Woollahra Local Planning Panel (Electronic Meeting)

LOCAL PLANNING PANEL DEVELOPMENT APPLICATION ASSESSMENT REPORT

ITEM No.	D1
FILE No.	DA157/2023/1
ADDRESS	6 Hopetoun Avenue Vaucluse
COUNCIL WARD	Vaucluse
SITE AREA	726m ²
ZONING	R2 Low Density Residential
PROPOSAL	The demolition of a dwelling house, the construction of a new dwelling house and swimming pool, landscaping and site works
TYPE OF CONSENT	Integrated development (Water Management Act 2000)
COST OF WORKS	\$4,047,862
DATE LODGED	10/05/2023 original lodgement 28/06/2023 first amended application 02/11/2023 second amended application 21/12/2023 amended landscape plans
APPLICANT	C G Benjamin
OWNER	K J Kelly & C G Benjamin
AUTHOR	Mr D Booth
TEAM LEADER	Mr M Moratelli
SUBMISSIONS	Six unique submissions (four from the owners of one adjoining property)
RECOMMENDATION	Conditional approval

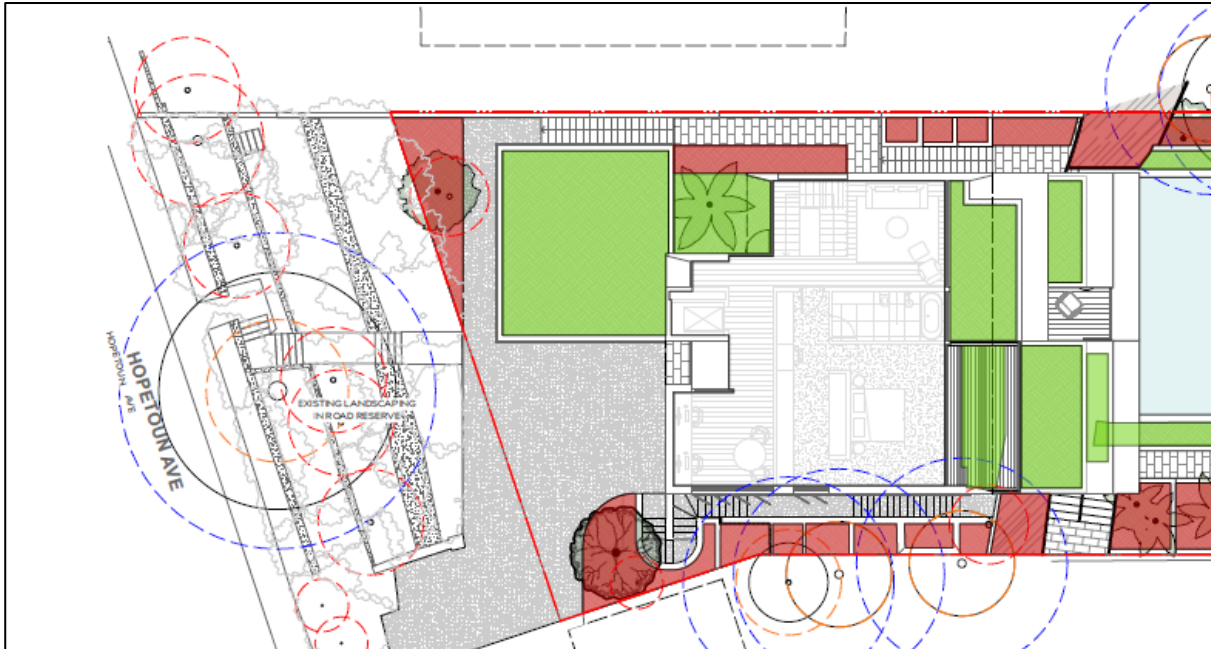
- Tree Nos. 16-18 *Musa sp.* (Banana) are located on the adjacent property. No objection to proposed works.
- Tree No.19 *Washingtonia robusta* (Mexican Fan palm). This is a palm tree is located within the rear setback of the property. It is proposed to be retained and protected on the AIA and LP, however the Stormwater Plan Rev. C shows a Rainwater (RW) tank being installed at rear requiring the removal of the tree.

The AIA indicates “the tree is a well established Washingtonia robusta located within the lower garden. This will have been planted as part of the sites earliest works and has been considered as being of High Value and documented for retention.” Therefore, the Stormwater Plan (SP) must be modified to retain the tree.

Please note both the AIA and the LP show SRZ and TPZ that are incorrect. The dimensions of the tree are also incorrect. The tree has a height of approximately 16m with a crown diameter of 4m. Therefore, the TPZ is 3m.

Amended SW Plan Rev. 2 shows a RW tank proposed at rear requiring the removal of Tree No.21. In order to retain this tree, the tank shall be modified.
